UNITED STATES PATENT AND TRADEMARK OFFICE

APPLICATION NO.	FILING DATE	FIRST NAMED INVENTOR	ATTORNEY DOCKET NO.	CONFIRMATION NO.
10/529,558	06/17/2005	Hiromichi Mizuno	59511.00003	7931

Office Action Summary	Application No. 10/529,558	Applicant(s) MIZUNO ET AL.	
	Examiner Jeffrey Sharp	Art Unit 3677

DETAILED ACTION

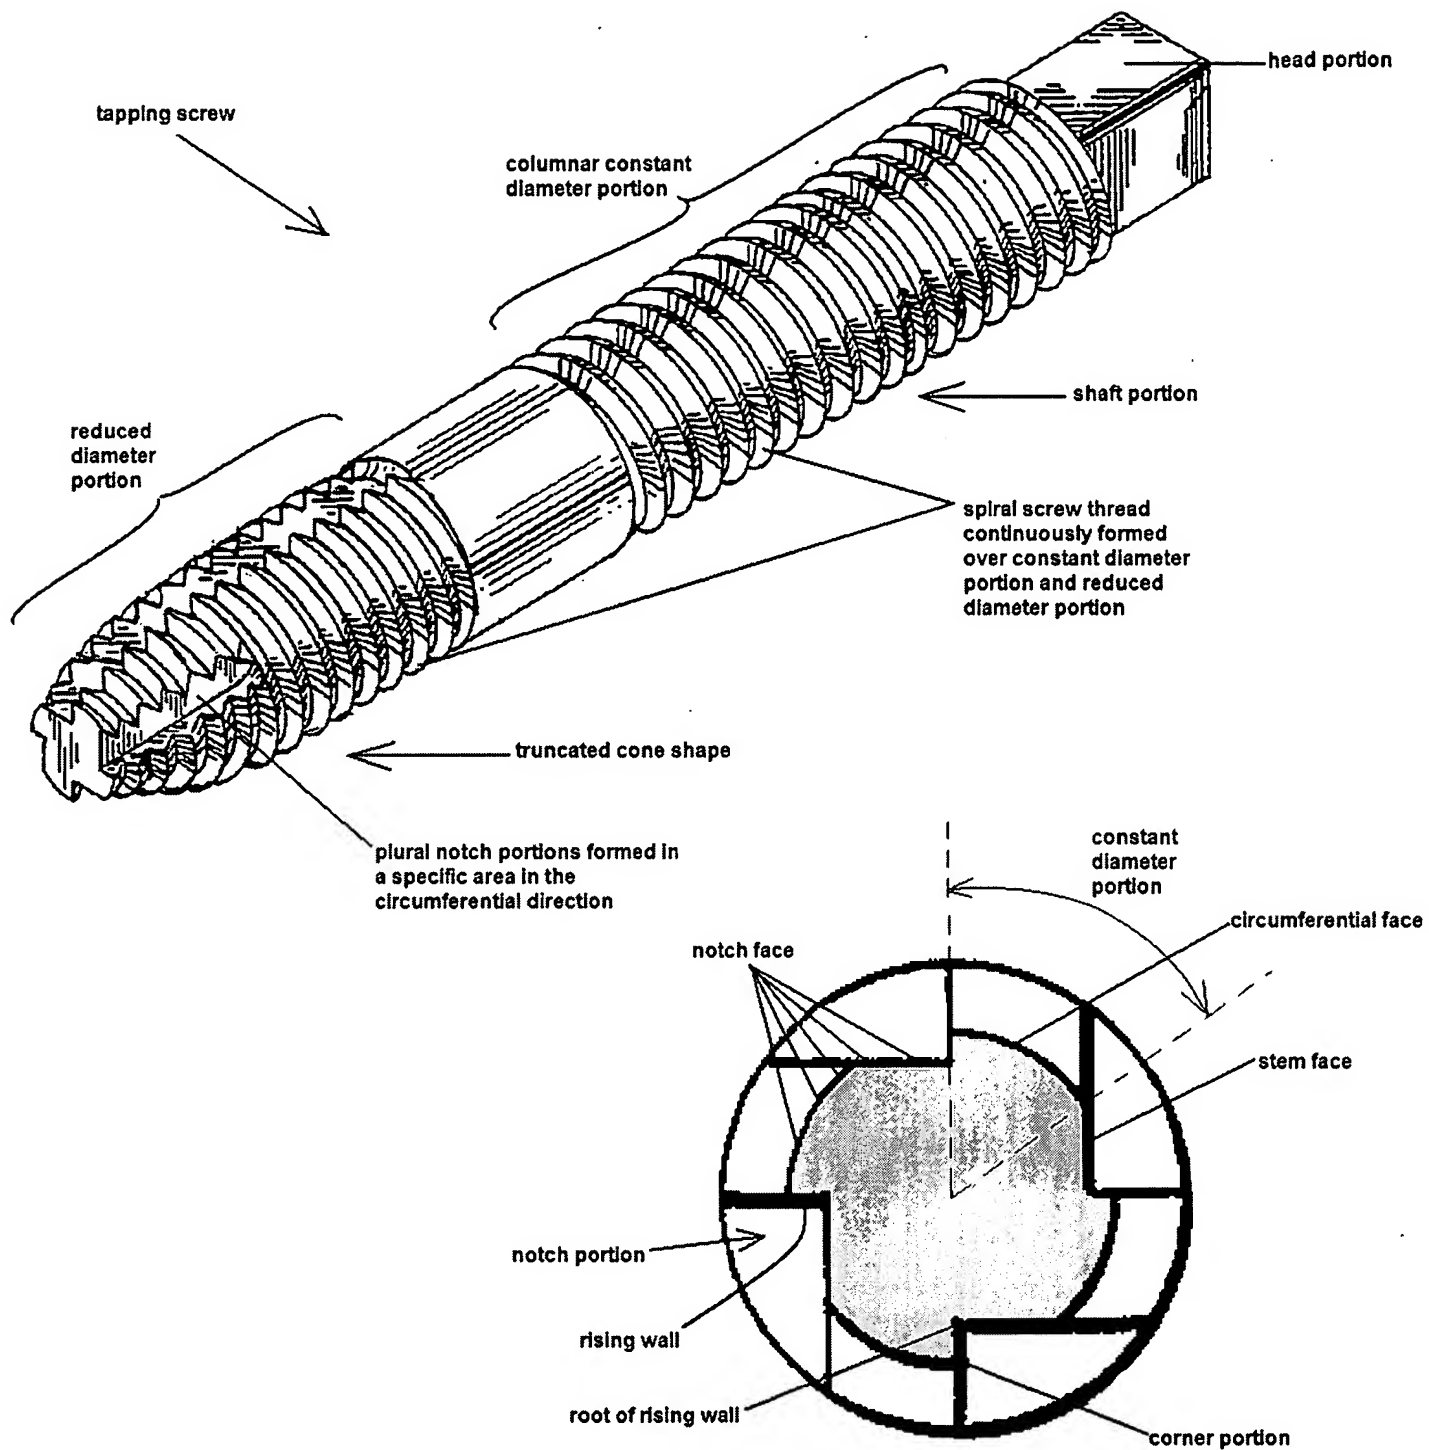
[5] Claims 1-8 (as they are understood) rejected under 35 U.S.C. 102(b) as being anticipated by Russo US-4,673,323 as clearly illustrated below.

In short, Russo teaches a tapping screw having a head portion, shaft portion having a thread, and truncated cone shape portion having a thread. The truncated cone shape portion is a reduced diameter portion having plural notch portions in a specific area. Each of said notch portions includes a notch face, rising wall, and corner portion formed at a diametrical outside of the rising wall; wherein said notch face has a stem face notched and formed on the diametrical inside from the top of said thread. The thread is (broadly) "shaved" at a top portion thereof, and at least a portion of the screw thread is left in said specific area.
